Technical Service Bulletin

19 Coolant warning light on OR Coolant pump replaced due to a coolant leak - 4.0 TFSI

19 22 30 2065040/2 August 31, 2022. Supersedes Technical Service Bulletin Group 19 number 21-25 dated November 13, 2021, for reasons listed below.

Figure 1. Mechanical coolant pump.

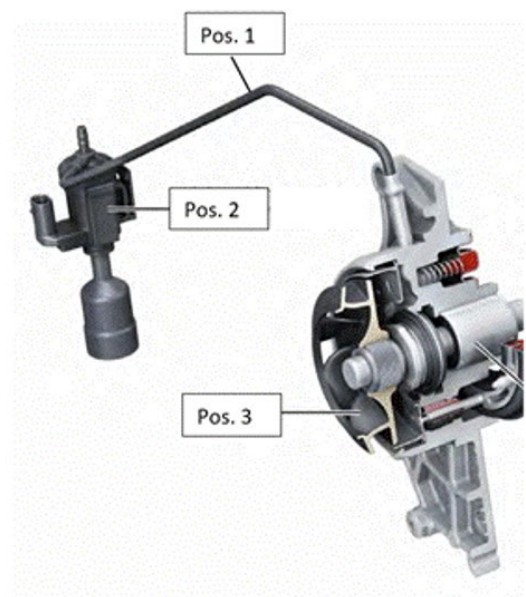
When performing work on the cooling system which requires the mechanical coolant pump to be replaced, it must be ensured that there is no coolant residue or fluid in the control line (Figure 1, position 1). If there is, switch valve N649 must also be replaced in addition to the coolant pump and the control line must be cleaned/dried.
